Relocation of Sham Tseng Sewage Treatment Works to Caverns – Feasibility Study

Public Engagement Report (Stage 2)

240268-REP-124-06

Revised Final 最終修訂 | March 2021, 2021 年 3 月

Figure 21 – Alternative Locations of Caverns

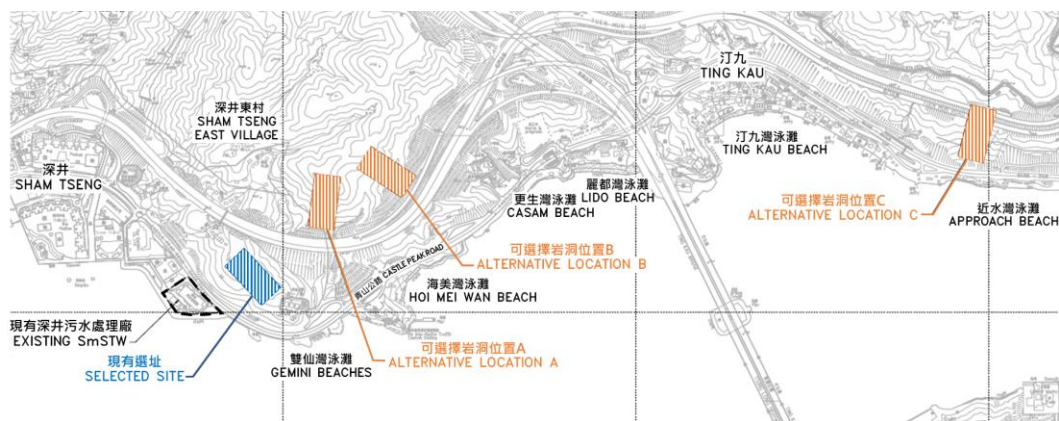
4.2.1.1 During the ad-hoc meeting with Hon Michael Tien, TWDC member Mr. Cheng Chit Pun and representatives of residential estates/villages in Sham Tseng, Hon Michael Tien requested the Government to review the portal location for the relocated SmTSTW.

*The access point to cavern is subject to several limitations. It has to be complied with the road design requirements, such as turning radius, elevation change, etc. It also bounded by the location of cavern which is governed by numbers of selection criteria, such as adequacy of rock cover, and quality of rock mass. There were three other alternative locations (namely alternative locations A, B & C as shown in **Figure 21**) that have been studied. Based on the selection criteria, alternative locations B & C were not considered favourable for cavern development (no suitable portal location, insufficient rock cover, and poor rock mass quality). However, the remaining alternative location A would be using the same access point as the selected site, in order to fulfil the road design requirement for the portal. Comparing the alternative location A to the selected site, rockhead of alternative location A is not as shallow as that of the selected site so more excavation works is required and the project cost is increased. Based on the available ground investigation records, alternative location A has deeper weathering and poorer rock mass quality than the selected site, therefore it is considered to be less favourable. Besides, alternative location A has lower cost-effectiveness since additional pumping station would be required to pump the influent from area further away from the majority of the sewage generation area. Therefore, the selected site with the access point located behind Golden Villa was chosen to be the relocation site of cavern SmTSTW.*

Figure 22 – Alternative Site after PE2
圖二十二、替代選址的岩洞位置

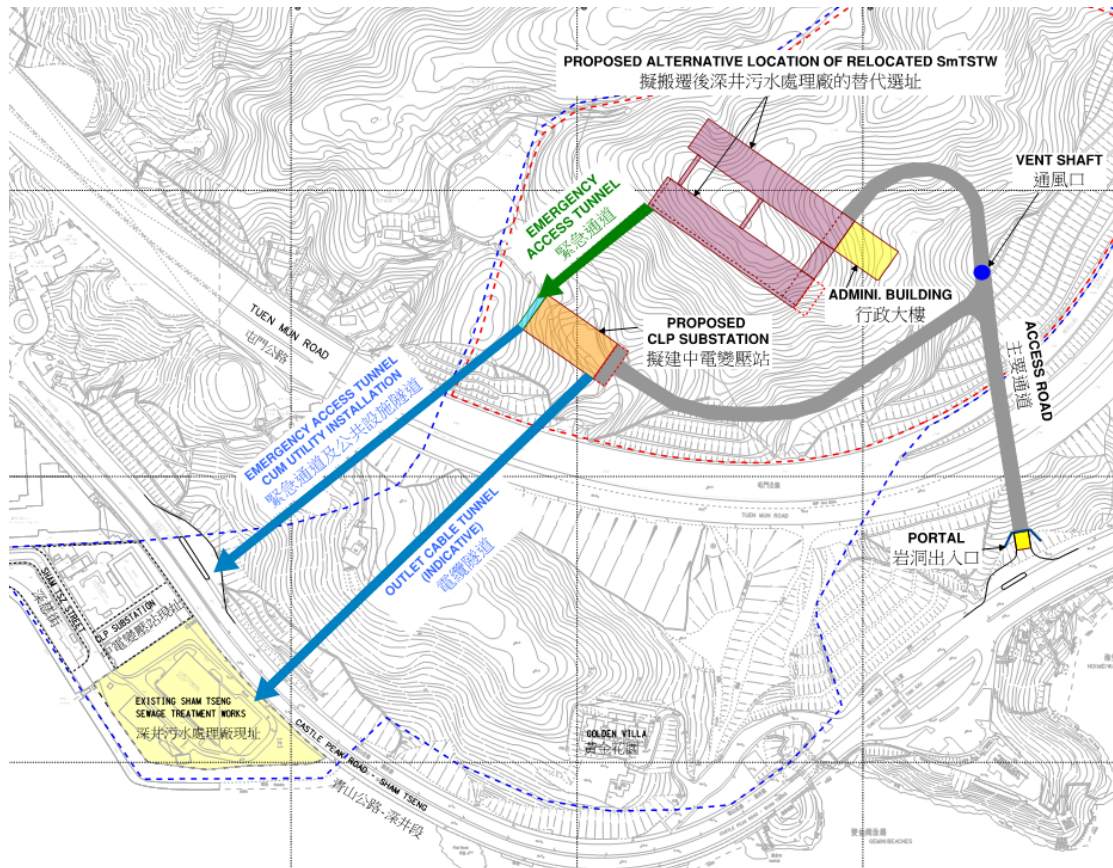
4.2.1.2 During the ad-hoc meeting with Hon Michael Tien, TWDC member Mr. Cheng Chit Pun and representatives of residential estates/villages in Sham Tsang, the representatives of residential estates expressed their concern on the close vicinity of the future ventilation shaft to local residents. They considered long-term cumulative effect of inhalation of the exhaust gas from SmtSTW would jeopardize their health. Hon Michael Tien requested the Government to review the feasibility to locate the shaft higher or further away from the residential area. 與立法會議員田北辰、荃灣區會議員鄭捷彬及深井居民代表會面期間，深井居民代表表示關注未來污水處理廠出風口的位置，擔心長期吸入污水處理廠排出的氣體會危害健康。田北辰議員要求政府探討遷移出風口至較高及更遠離民居的位置。

*Subsequent to PE2, an alternative site has been identified (See **Figure 22**). The location, arrangement and alignment of caverns are reviewed with additional ground investigation. Comparing to the conforming scheme, the portal connecting to Castle Peak Road is moved eastward to Hoi Mei Wan which can avoid traffic impact to the local access to Golden Villa during the construction and operation stage of the*

relocated SmTSTW. Also, large site formation works is not required near Golden Villa to build the portal.

*Subsequent to PE2, an alternative site has been identified (See **Figure 22**). Comparing to the conforming scheme, the ventilation shaft is further far away from the sensitive receivers and the air quality / odour impact would be further reduced.*
